- Windows

- Same window specs as Staudenmeier?
  - Throughout entire project?

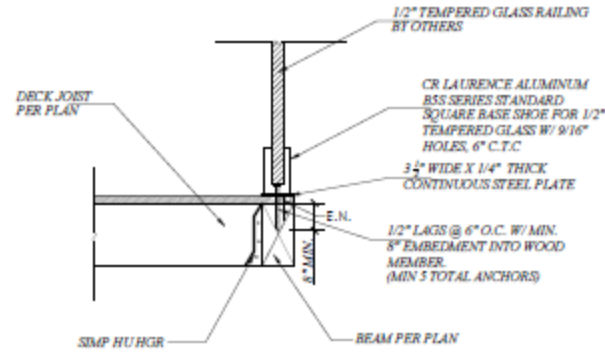
- Doors

- Same as Staudenmeier?  
**We expect to use Fleetwood for all doors and windows in this project.**
- Wood gate at surf storage
  - Spec? Custom?  
**Custom**

GUARDRAIL / HANDRAIL TO DECK CONN.

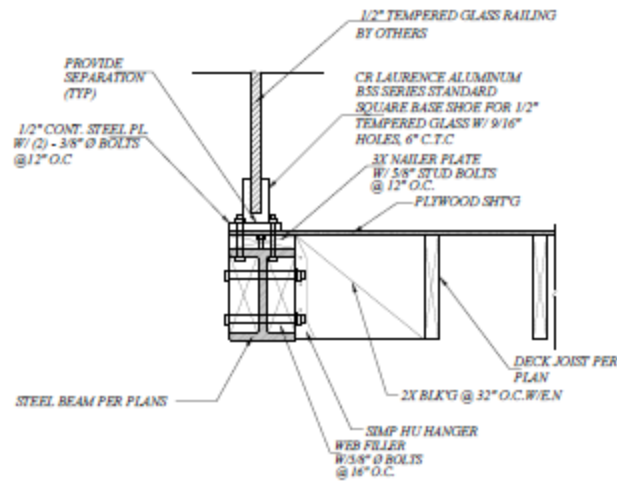
- Spec?  
**No wood decking proposed. All decks to be stone over Buzon pedestals. Over Westcoat decking:**  
<https://www.westcoat.com/systems/alx-tile-ut/>
- Glass Railing
  - Spec?
- Gutter
  - Integral gutter
    - same design as Staudenmeier?  
**Yes**
- Soffit
  - Wood
    - Spec?  
**Coulson Cedar ceiling 1x6**  
<http://coulsonmanufacturing.com/>
- Roof
  - BUR
    - You actually want BUR roofing? Or could you use EPDM w/ gravel, which I understand is a more common system?
- Stair
  - Tread and stringer like Staudenmeier?  
**No. This will be two side metal stringers with wood treads in between. Structural to follow.**
  - Glass railing
    - Any design direction?  
**Per the structural plans:**

**A1** Section A - 1  
1/2" = 1'-0"

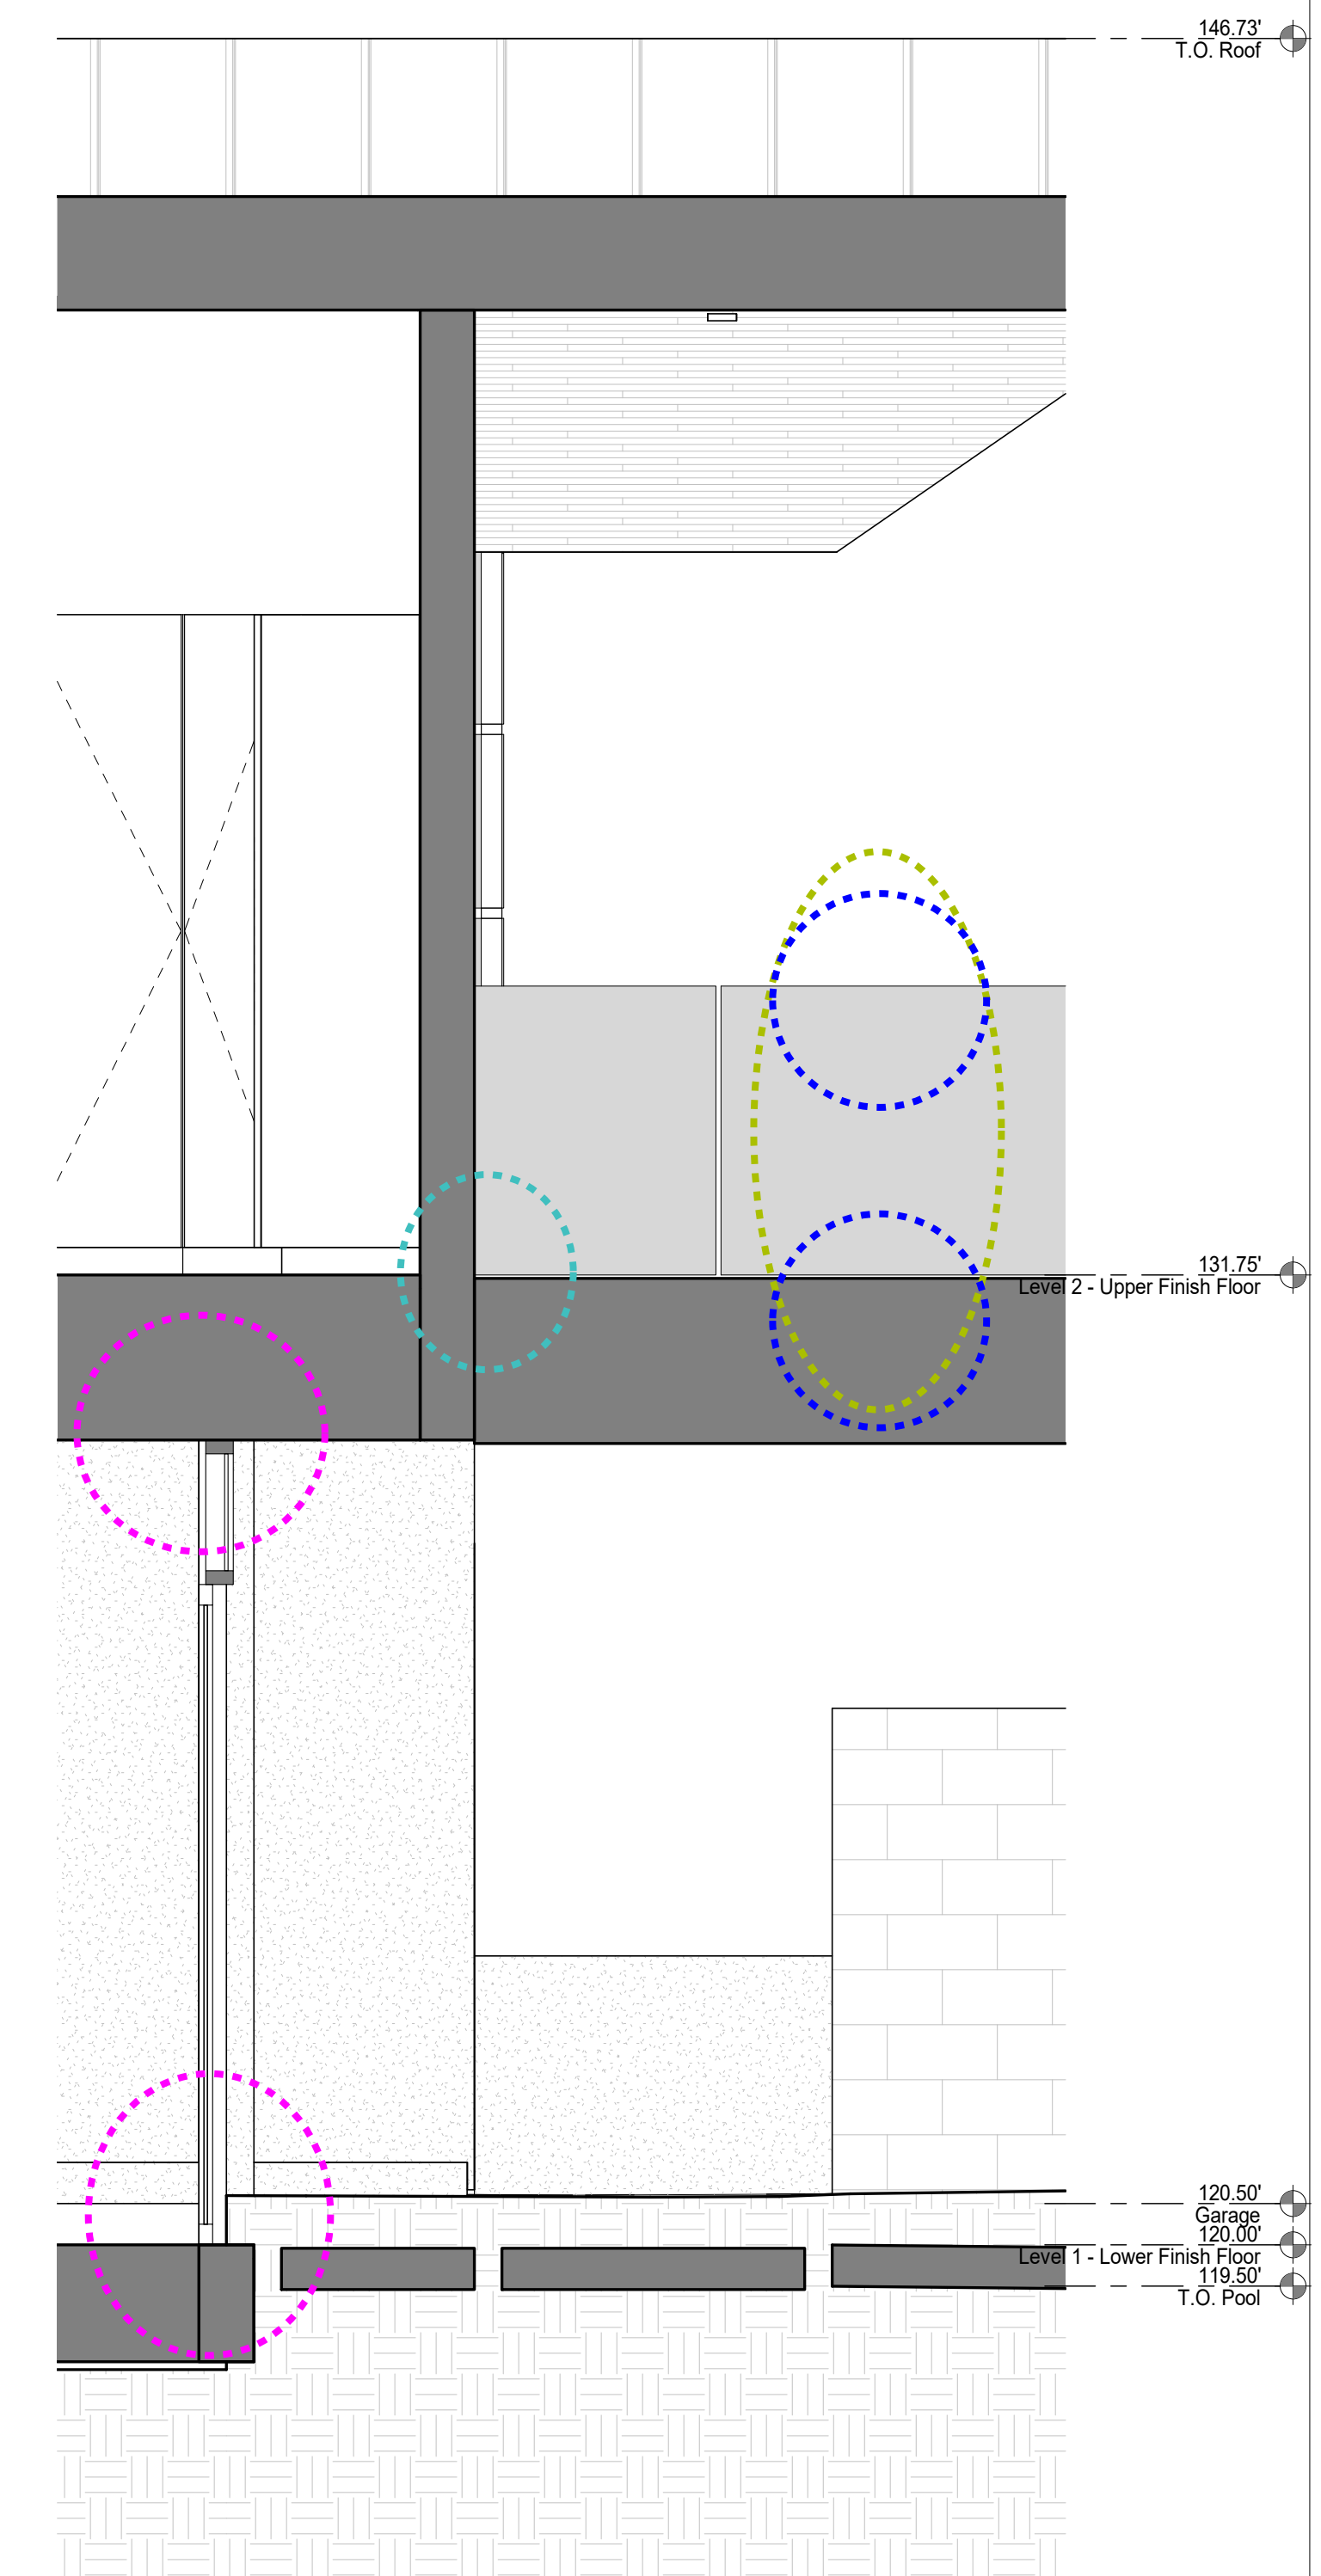
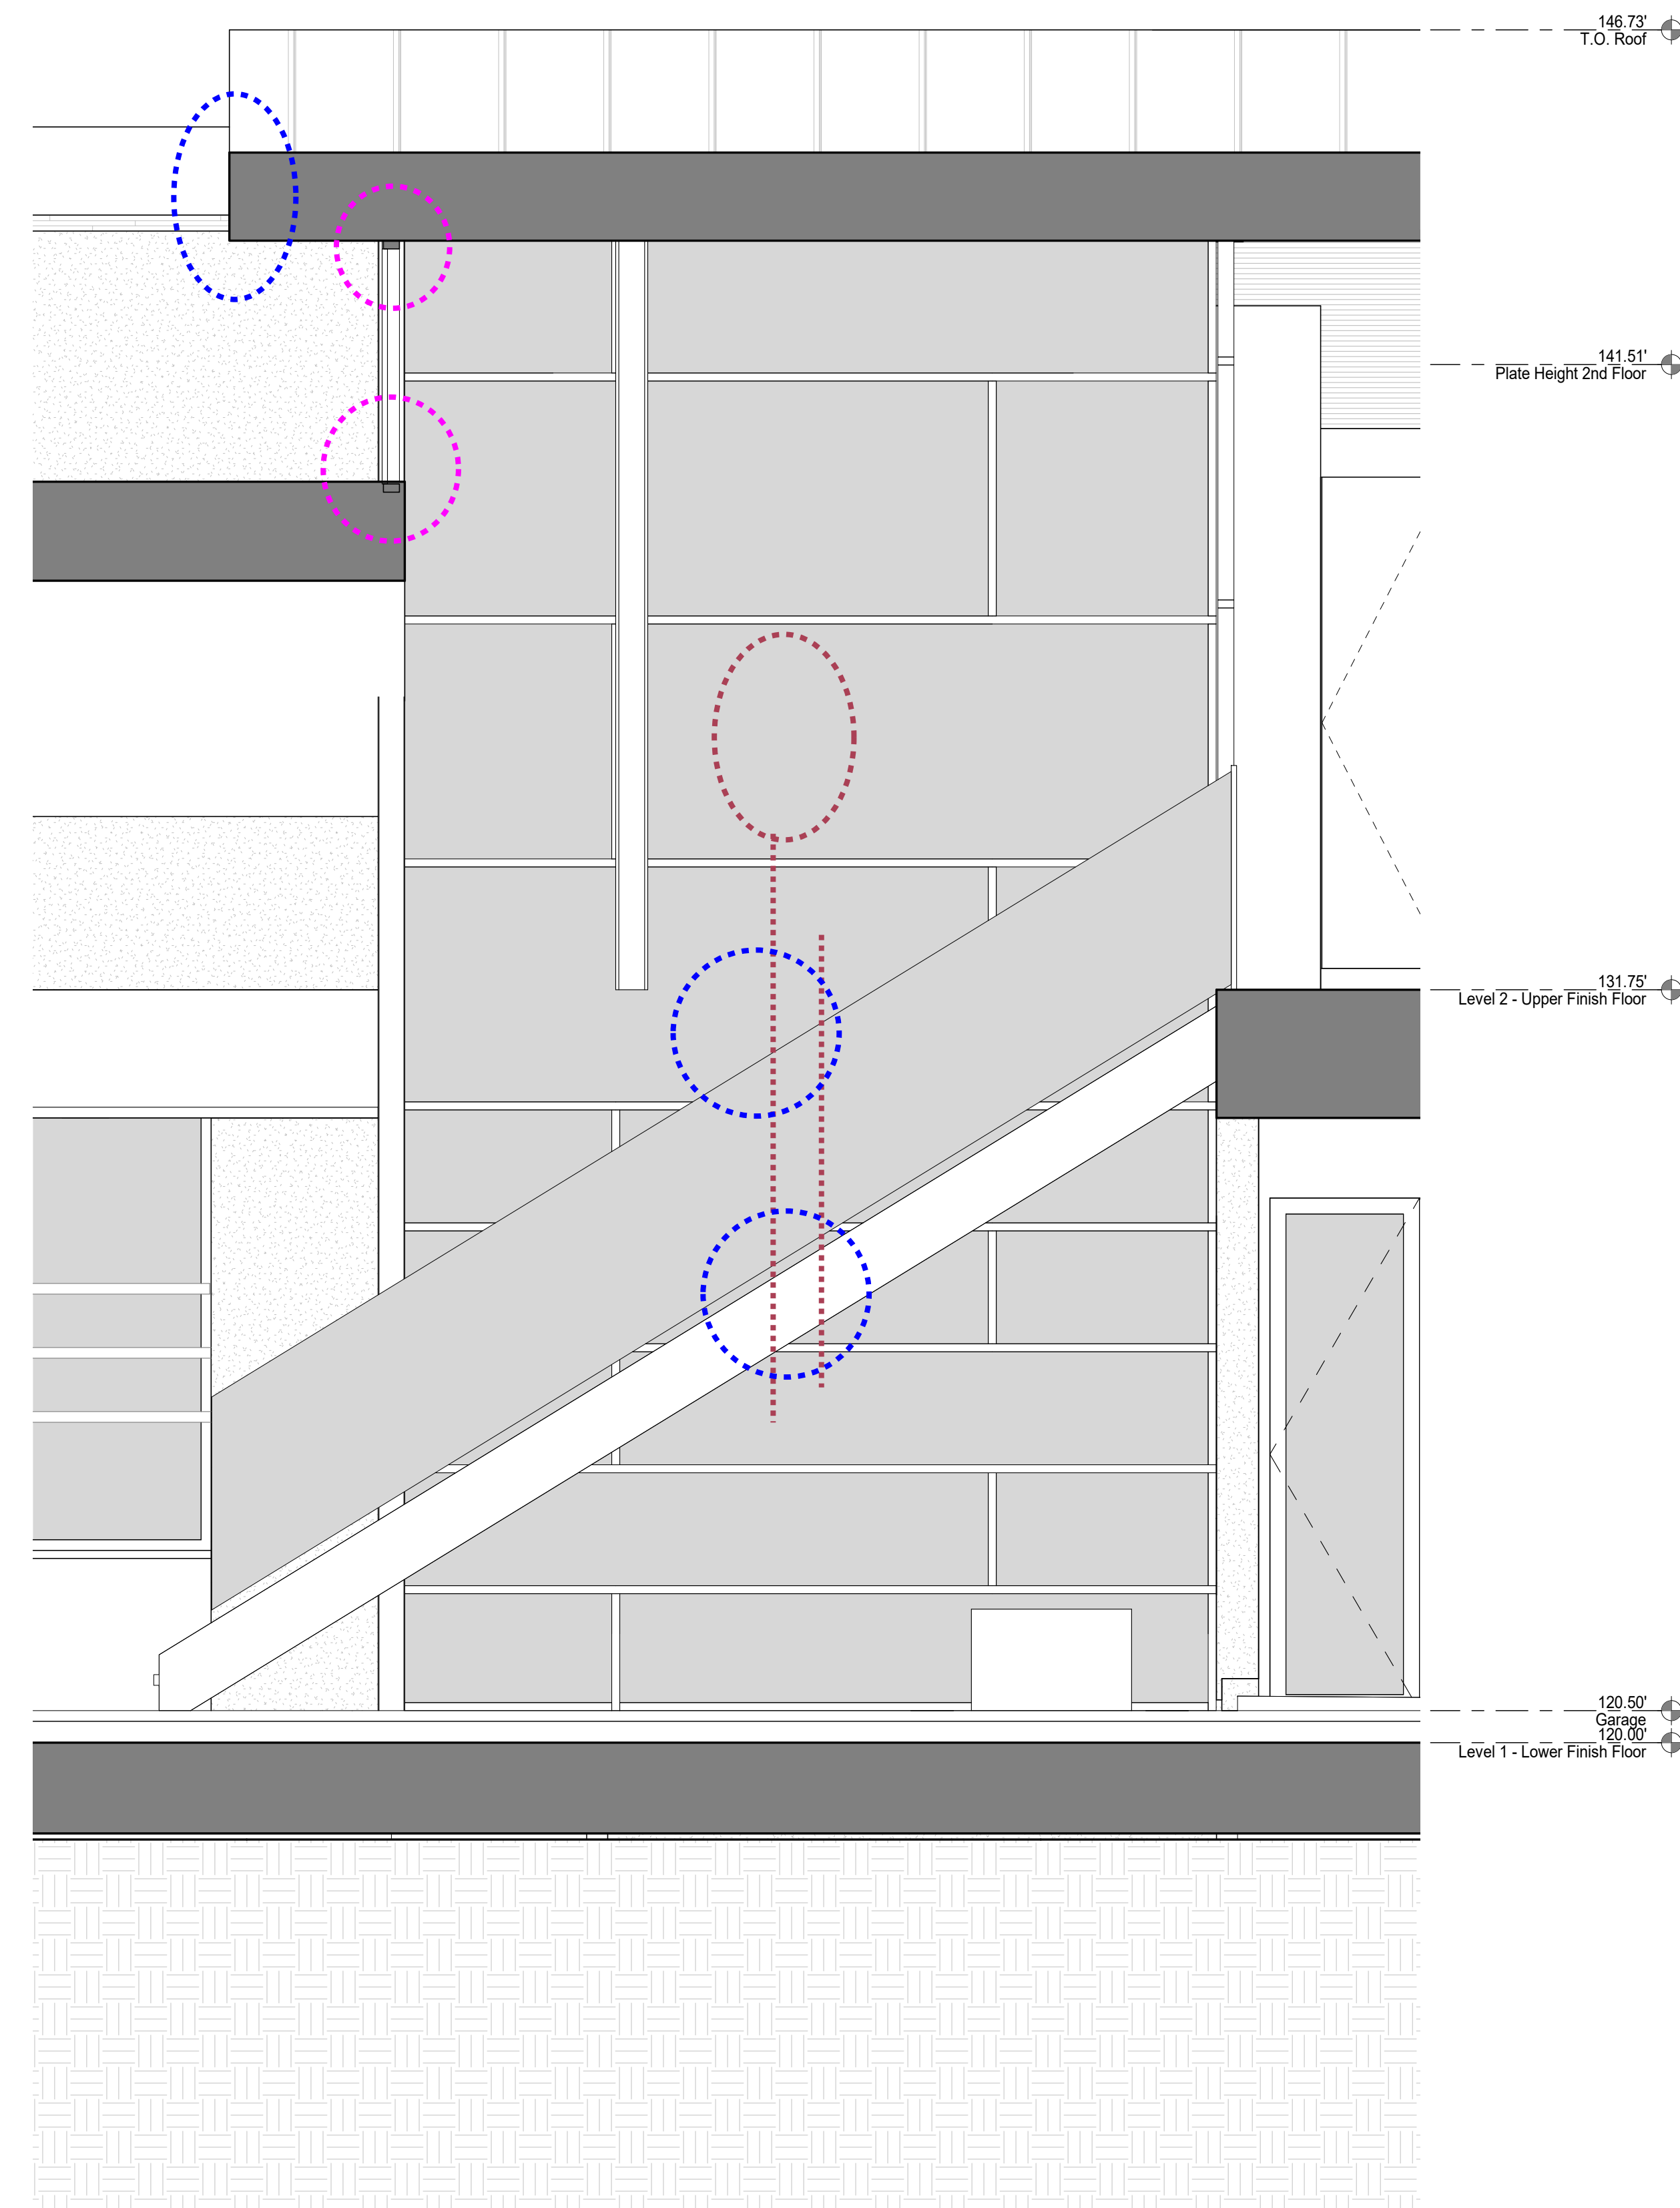
stucco to hide stone  
tile. stone tiles/  
buzon pedestals/  
West coat deck  
coating (sent you a  
link) O/ framing

at the edge, do you  
see the stone tile?  
or does the  
stucco/gypsum  
board hide the  
stone?

the revit roof object  
has this as 'Gypsum  
Wall Board'  
Is that correct?  
Or stucco?

were you envisioning  
this split stone over  
a CMU backer wall?  
Or just stacked stone  
w/ mortar?

footing?

stucco @  
exterior  
Now  
corrected  
in the new  
model

will  
confirm  
with  
structural
